## MEMORANDUM

**Subject:** Daniel Schlegel  
d(4) Floor Area Ratio Variance  
Block 16.01 Lot 8  
15 Hereford Drive

**Date:** September 14, 2019

Map 1: Aerial of Subject Site (scale: 1" = 200')

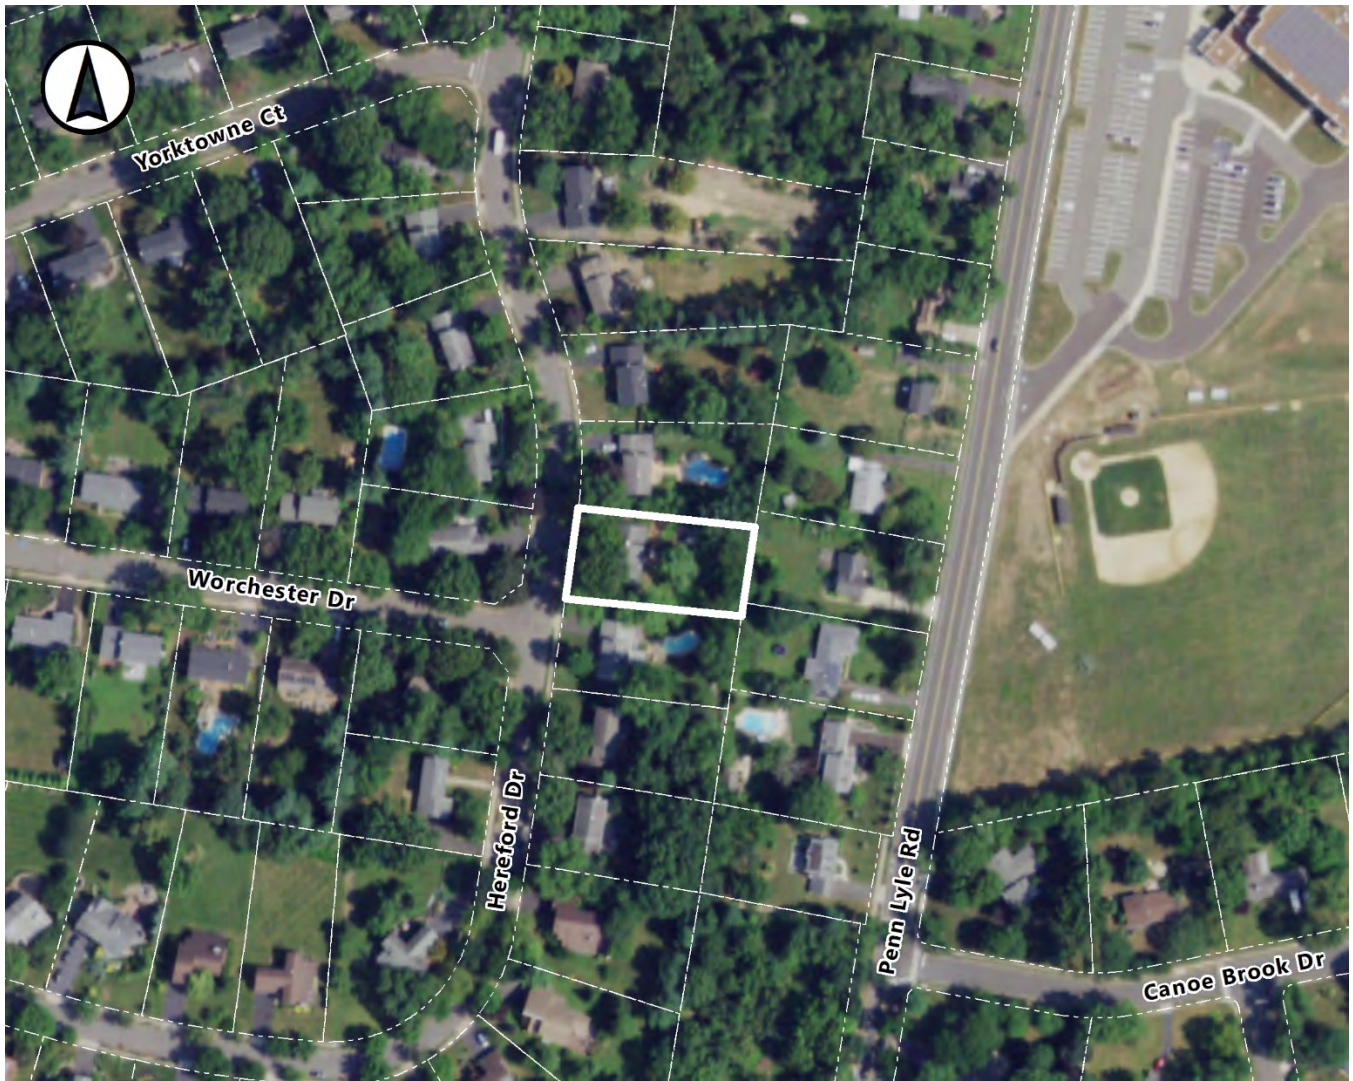
Surrounding land uses consist predominantly of single-family dwellings. West Windsor-Plainsboro High School South is located approximately 250 feet to the east. Please see the aerial at the end of this memorandum for an overview of the subject site and its surrounding environs.
